Date: February 15, 2013
Order No.: T-B-46.30/13b
Supersedes: T-B-46.30/13a, December 21, 2007 (DTB)
Group: 46

SUBJECT: Model 163.154/157/172/174/175

**10 Year/Unlimited Mile EXTENDED WARRANTY FOR CLAMP AND LOWER POWER
STEERING HOSE**

Figure 1

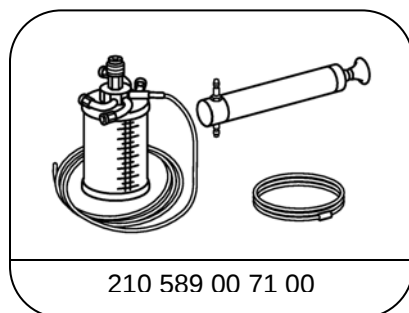
NOTE: Figure 1 illustrates the new hose and clamp (screw type clamp) connection design listed in the parts information section. Further movement of the hose is prevented by a flare at the end of the nipple extending from the radiator.

If you receive customer reports in the above model vehicles of power steering leaks from the connection to the power steering cooler, please replace hose and clamp according to WIS document Number AR-46.25-U-0008GH with repair set.
